BLOOMINGTON BOARD OF ZONING APPEALS CASE #: V-32-23 / VAR2023-09-0013
STAFF REPORT

DATE: November 16, 2023

Location: 503 North Rogers Street

REQUEST: Variances from front building setback standards, use-specific standards for multifamily dwellings, and building design standards to allow construction of four buildings comprising a mixed-use development in the Mixed-Use Downtown zoning district within the Showers Technology downtown character overlay (MD-ST)

Building One Elevations

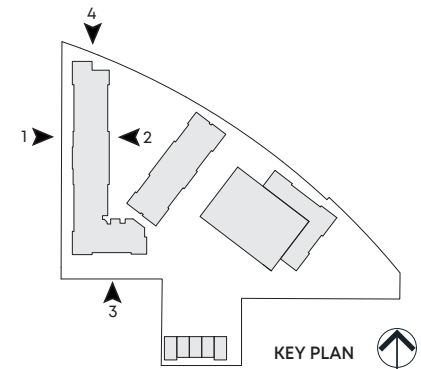
3. UDO section 20.02.050(a)(5) Upper Floor Facade Step Backs
 Required: *Portions of the building facade facing the street above two stories in the DG and ST character area shall step back from the lower story vertical facade/wall plane a minimum of 15 feet.*
 Proposed: No upper story step back for Building One along Fairview Street and Building Three along Rogers Street.

Building One is proposed to be four stories in height, while Building Three is proposed to be five stories in height. Full compliance with this upper floor step back standard would require

the third and fourth stories (and fifth story on Building Three) to be stepped back at least 15 feet from the front facade of the first two stories. Instead, the petitioner has proposed facades that rise the full height without any step backs.

Due to the UDO's limitations on the building floor plate standards, Building One is designed with a width that varies from approximately 62 feet to approximately 75 feet. The interior layout is arranged with a central corridor and dwelling units on both sides. Reducing this width on the upper stories by at least 15 feet would prevent the central corridor layout, effectively reducing the upper stories to only one row of dwelling units per floor.

The total length of west facade Building One along Fairview Street is approximately 367 feet. An off-set of at least five percent of this would have to be nearly 18.5 feet. Instead, the petitioner is proposing facade modules that are off-set by projections and recesses of at least 5 feet.

6. The west facade of Building One facing Fairview Street shall consist of no fewer than seven facade modules off-set by projections or recesses of at least five feet in depth. Each of the seven facade modules shall have a length between a minimum of 30 feet and a maximum of 100 feet.

Building Two Elevations

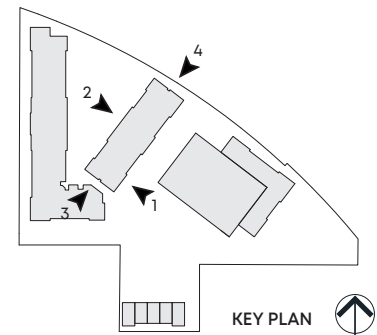
Because the petitioner proposes dwelling uses for the ground floors of Buildings One, Two, and Four, the proposed facade designs show fenestration appropriate for residential use with windows and doors comprising at least 20 percent of the ground-floor facade area. However, these primary facades are not compliant with the applicable UDO standard for windows and doors.

The portions of the proposed buildings that do not contain ground-floor dwelling units, including the north facade of Buildings Two and Three facing the B-Line trail as well as the east facade of Building Three facing Rogers Street provide glazing appropriate for nonresidential ground-floor uses with windows and doors comprising at least 60 percent of the ground-floor facade area. These primary facades are compliant with this UDO standard.

Building Three & Townhome Elevations

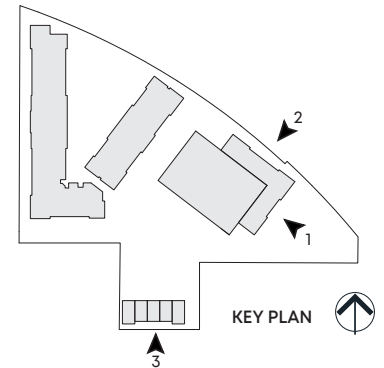
Building Three is designed with primary uses (commercial tenant space and amenities on the ground floor, and dwelling units on upper floors) wrapping around a parking structure. Due to the building floor plate standards, the width available for the primary uses varies from approximately 33 feet to 38 feet. Reducing this width on the upper stories by at least 15 feet would effectively prevent usable dwelling units on the upper stories.

The total length of the east primary facade of Building Three along Rogers Street is approximately 126 feet. Due to the angle of the building orientation, the southernmost portion of the east facade that is set back, and which contains a stairwell and a portion of the parking structure, is at no point the nearest portion of the facade to Rogers Street and therefore may be considered not to be part of the primary facade along Rogers Street. An off-set of at least five percent of the primary facade's 126 feet would have to be 6.3 feet. Instead, the petitioner is proposing three facade modules that are off-set by from each other by recesses of 5 feet.

The total length of the north facade of Building Three along the B-Line Trail is approximately 227 feet. An off-set of at least five percent of this would have to be more than 11 feet. Instead, the petitioner is proposing three facade modules that are off-set from each other by recesses of 5 feet, with a fourth facade module on the west end off-set by a recess of 38 feet.

7. The east facade of Building Three facing Rogers Street shall consist of no fewer than three facade modules off-set by projections or recesses of at least five feet in depth. Each of the three facade modules shall have a length between a minimum of 20 feet and a maximum of 100 feet.

8. The north facade of Building Three facing the B-Line Trail shall consist of no fewer than four facade modules off-set by projections or recesses of at least five feet in depth. Each of the four facade modules shall have a length between a minimum of 20 feet and a maximum of 100 feet.
